Project	IEEE 802.16 Broadband Wireless Access Working Group < http://ieee802.org/16 >	
Title	Text remedy on credit token based coexistence protocol for LB 29 reply comment	
Date Submitted	2007-09-07	
Source(s)	David Grandblaise Motorola Labs Parc Les Algorithmes Commune de Saint Aubin 91193 Gif sur Yvette, France	Voice: +33 (0)1 6935 2582 mailto: david.grandblaise@motorola.com
Re:	IEEE 80216h-07/053	
Abstract	This contribution is an accompanying document to the LB 29 reply comment database [2] of IEEE 802.16h/D3 [1]. This contribution provides some text remedy on the credit token based rental protocol (CT-CXP) as reply comments to comment #287, 288 and 297.	
Purpose	Material related to the reply comment of LB 29 for comment #287, 288 and 297.	
Notice	<i>This document does not represent the agreed views of the IEEE 802.16 Working Group or any of its subgroups. It represents only the views of the participants listed in the "Source(s)" field above. It is offered as a basis for discussion. It is not binding on the contributor(s), who reserve(s) the right to add, amend or withdraw material contained herein.</i>

Text remedy on credit token based coexistence protocol for LB 29 reply comm

Figure 61: Master subframe (OFDM symbols) sharing within CX-Frame

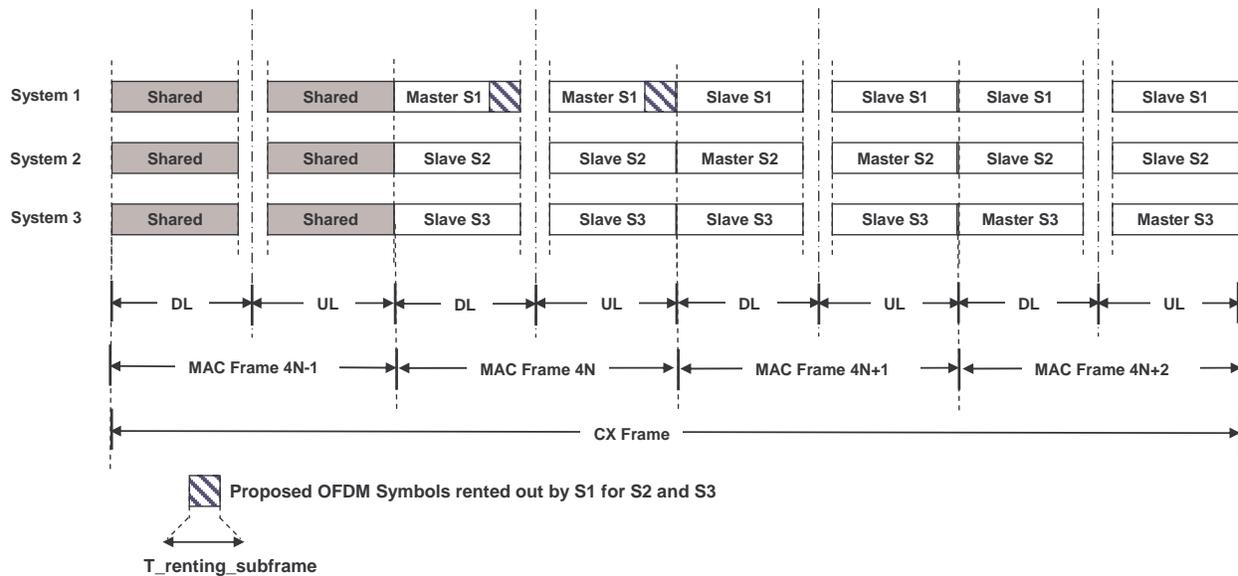
[Related to comment #287 and #288 resolution: Replace Figure h61 of section 15.4.5 with the following updated one as indicate:]
